Defrost circuit modification

On the older side-by-side refrigerators, manufactured prior to March 2007, that have drain ice buildup problems perform this modification. The evaporator cover with its foil backing is integral parts of the drain defrost circuit. The foil must make contact with the defrost heating element to transfer the heat to the drain.

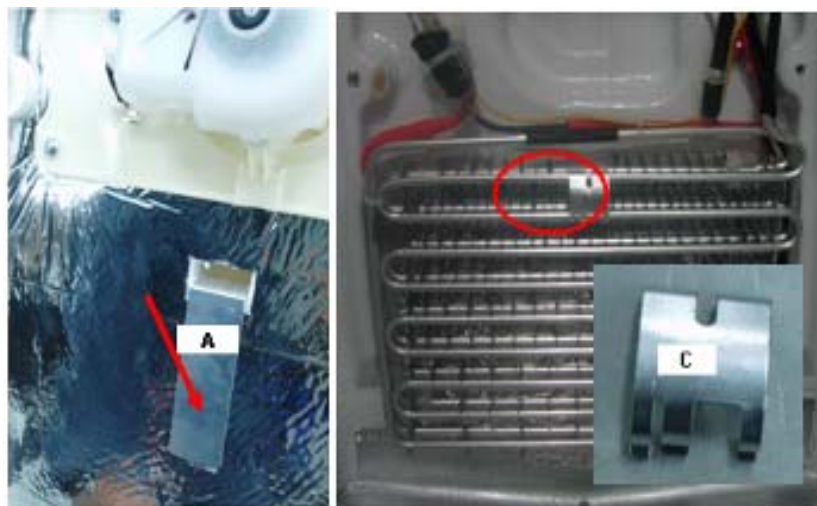
The cause of the ice buildup is:

1. The heat from the defrost heater is not transferring to the drain during a defrost cycle
2. The Styrofoam in the evaporator cover around the fan absorbs moisture and freezes
3. During the defrost cycle the ice on the Styrofoam will melt but refreeze
4. The amount of ice will eventually increase causing cooling efficiency to diminish
5. If the ice buildup grows, it can block the fan and stop it from spinning

To improve the defrost of the drain install the metal clips on the evaporator cover and evaporator coil.

Refrigerators that have this modification already can also have drain ice buildup if the two clips are not seated properly or where the contact surfaces have become corroded due to moisture buildup.

Part numbers for these parts are as follows:

A: DA61-03502A PLATE-DRAIN INS EVAP, REF

C: DA61-03585A FIXER-EVAP REF
